Access Compliance Report Public Rights-of-Way (Curb Ramps)

Main Street: N_SELLAS_RD		Cross Street: DELPHINIUM_ST		Location:	NE
ADA ID: RPAT211102101629	Ramp Type: Type 4 - Parallel	Initial Pass/Fail: Fail	Overall Compliance: No	Severity Score:	15
Codes/Mitigation Info/Possible Solution			Field Measurements/Component Compliance

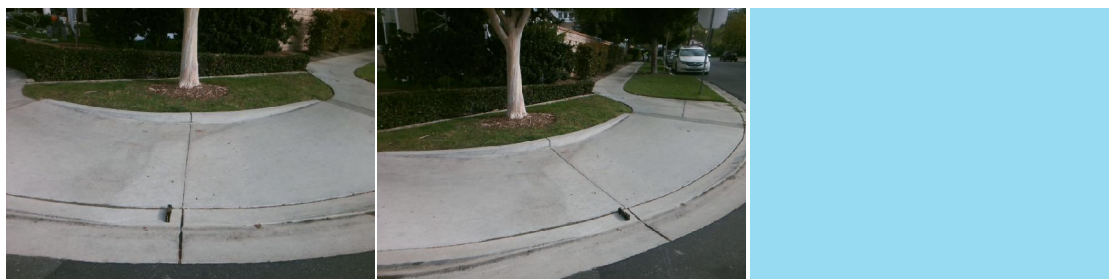
Remove & Replace Curb Ramp With Two New Directional Ramps or Equivalent.
